# **ESBWR**

#### Tier 1 Requests for Additional Information

NRC Meeting April 22, 2008

GE Hitachi Nuclear Energy

#### RAI Number 14.3-204

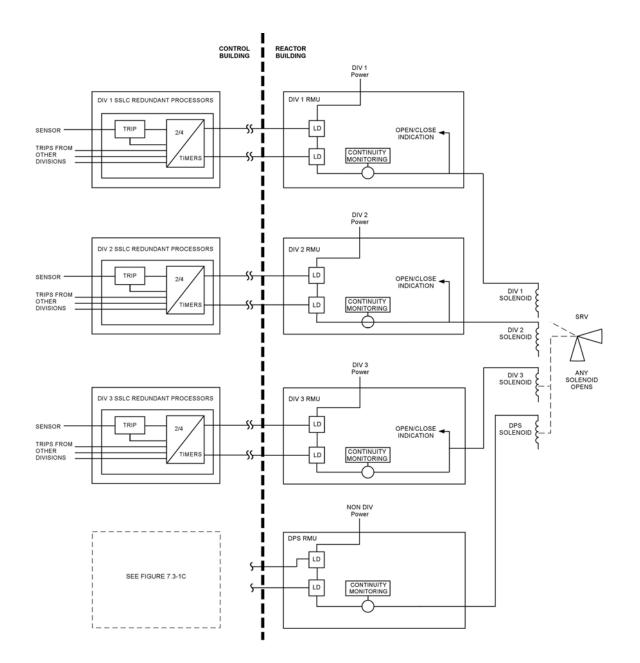
Relates to RAI 14.3-189

- These RAIs relate to testing of reactor internals
- Verification of assumptions for TRACG
  - Reactor internals pressure drops
  - Fuel bundle pressure drops
